Two guards. Separate fastenings.

WHY CHANGE: the previous four shared bolts retained both guards. R02G gives the upper and lower guards four separate bolts each, so removing one set does not release the other mounting.

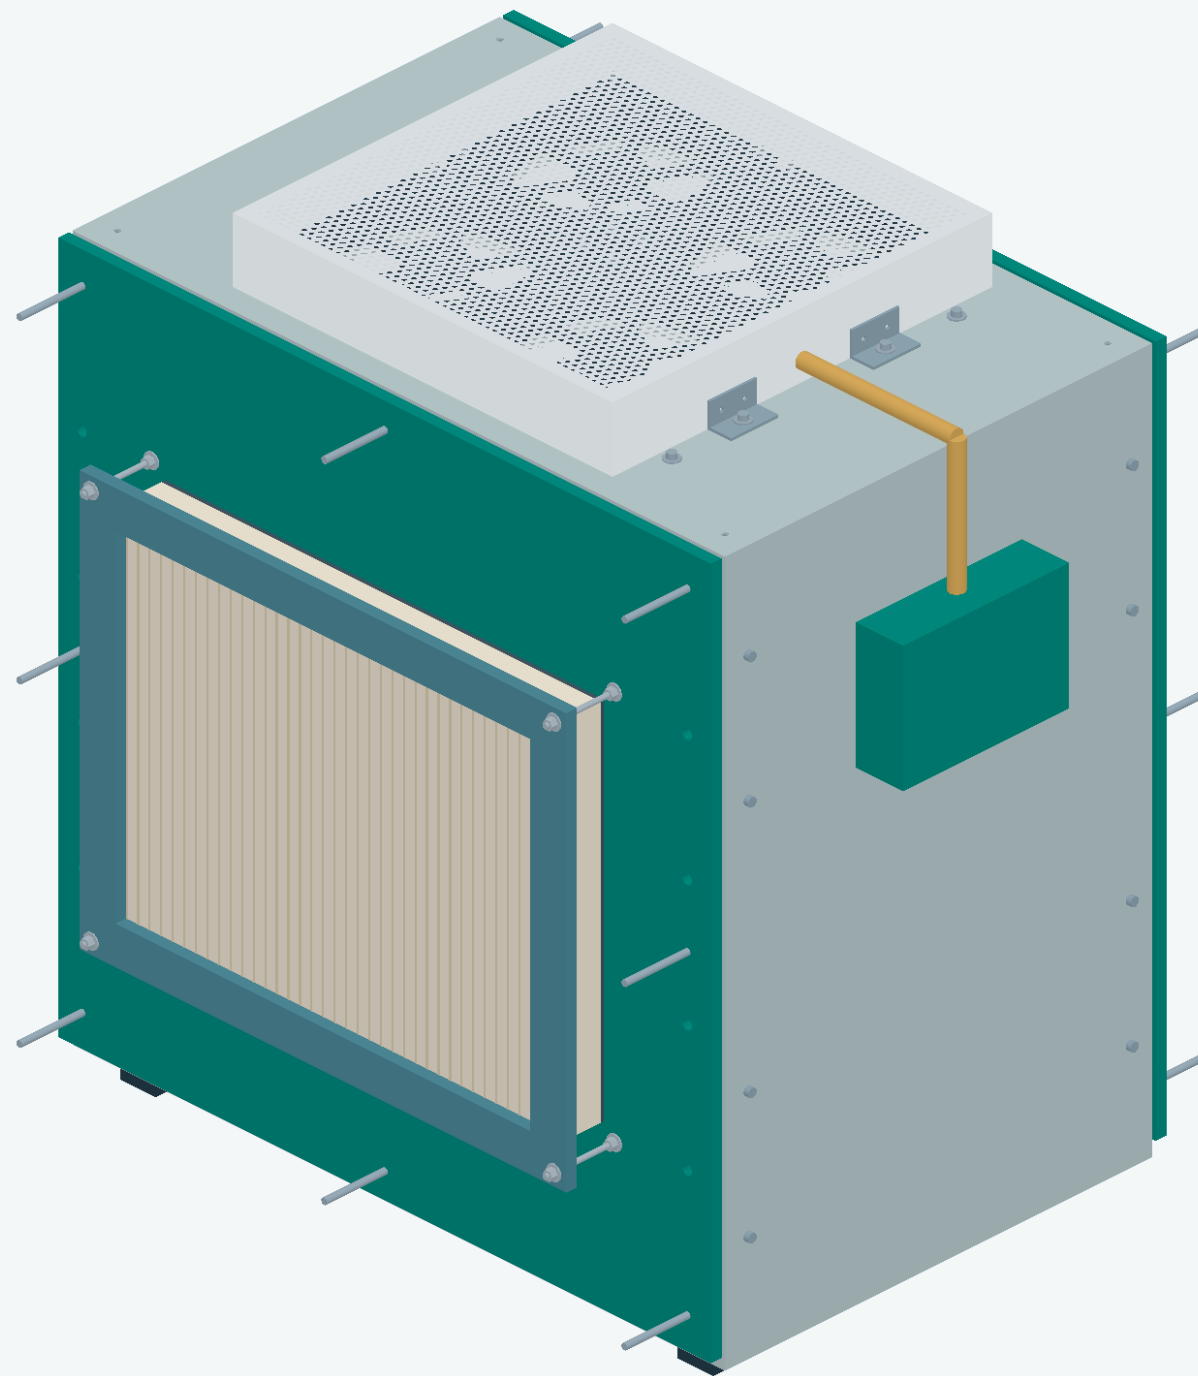
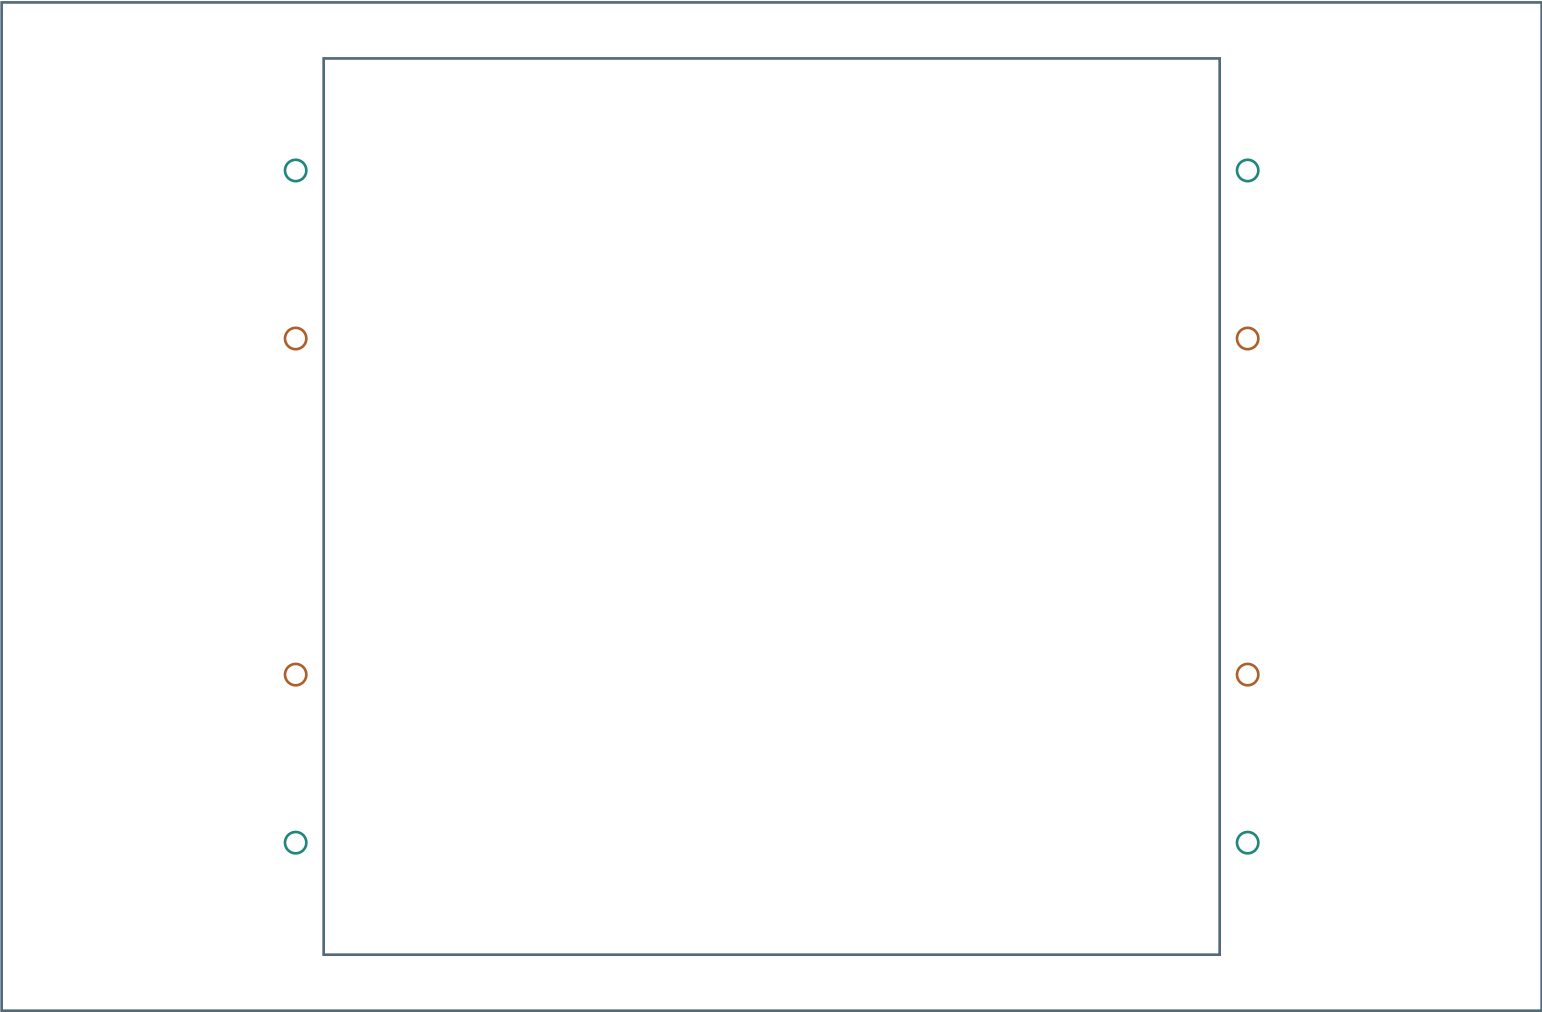
WHAT CHANGED: upper brackets moved along the sides; four extra holes added to the fan plate. Upper side-skirt rivet holes move with their brackets. Inner brackets retain their earlier positions.

OUTER GUARD: angle y100..140 and220..260, x95..115 /435..455, base z580..582. Screw head z583..587;20 mm shaft z563..583. Top washer582..583; bottom washer570..571; nut565..570.

INNER GUARD: angle y40..80 and280..320, same x positions, base z569..571. Screw head581..585;20 mm shaft561..581. Top washer580..581; bottom washer568..569; nut563..568.

BOTH: M4 x20 proposed screw; head7 diameter x4 high, nut7 across flats x5 high; washers12 OD x1 with assumed4.3 ID. Nominal thread projection2 mm. No torque/grade release.

OUTER SKIRT: new blank, diameter3.5 rivet holes at y110/130/230/250, z590 on both side skirts. OMIT prior y50/70/290/310 holes. Existing bracket holes travel with the brackets; no new bracket shape.
